# TERREBONNE LEVEE AND CONSERVATION DISTRICT

# Reach H, Segments 2 and 3

# Mitigation Plan Supplement to Revised Plan Dated June 4, 2008

MAY 13, 2013

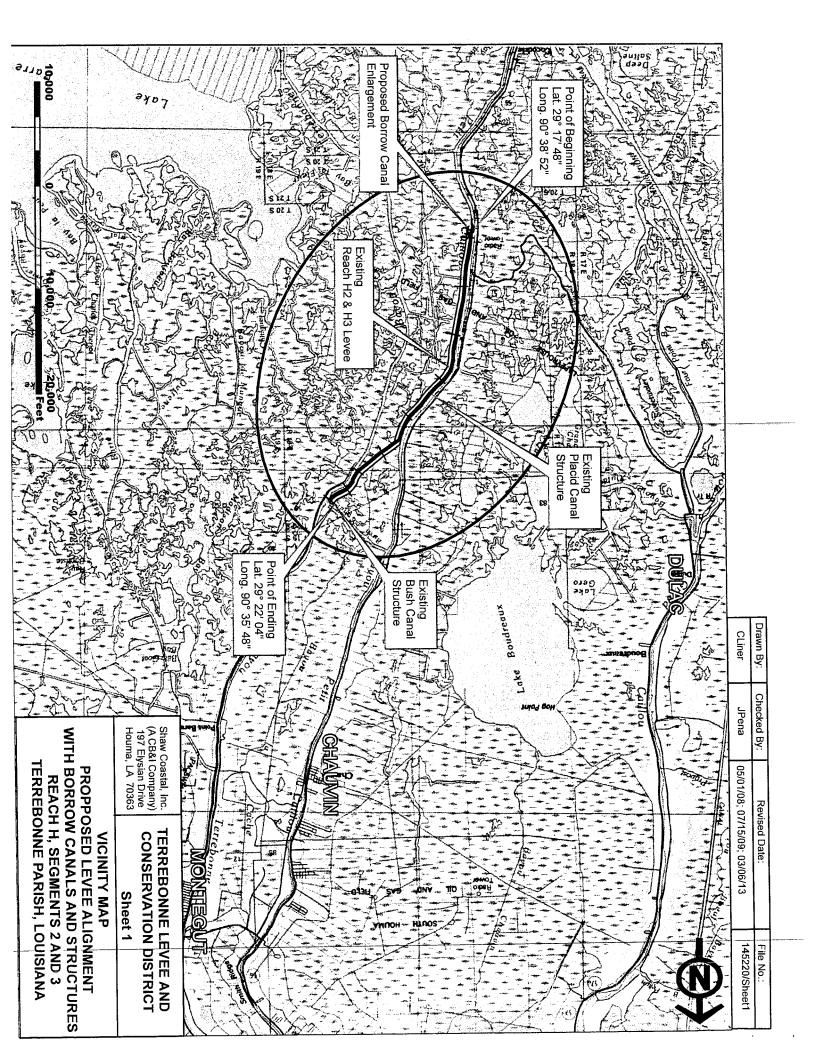
EXISTING REACH H2 LEVEE FOR FUTURE LEVEE IMPROVEMENT. ACCESS CANAL REMOVED TO CREATE A COMMERCIAL BOAT ACCESSIBLE CANAL. THE MATERIAL WILL BE STOCKPILED ON THE APPROXIMATELY 31,000 CUBIC YARDS OF MATERIAL

# TYPICAL CROSS SECTION

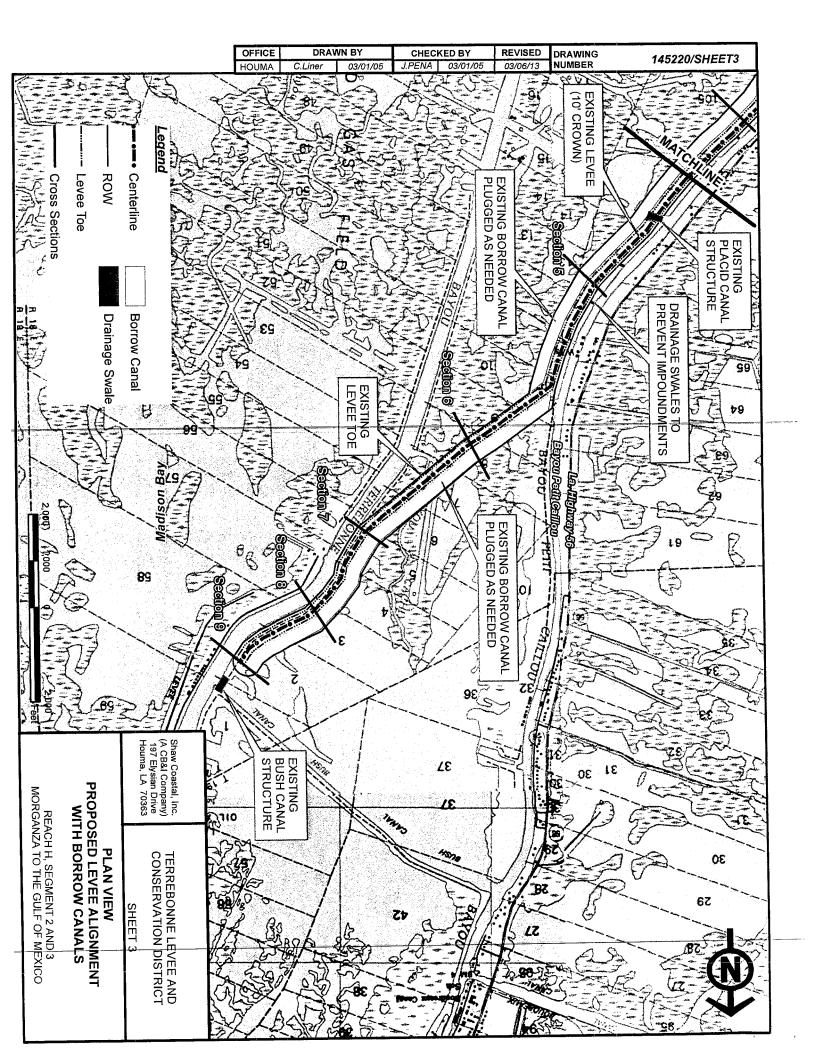
APPROXIMATELY 1,000 CUBIC YARDS OF RIP RAP WILL BE PLACED ALONG THE BANKLINE FOR EROSION AND STABILIZATION PURPOSES.

APPROXIMATELY 0.4 ACRES OF RIDGE HABITAT AND 0.5 ACRES OF MARSH HABITAT WILL BE IMPACTED BY THIS ACTIVITY.
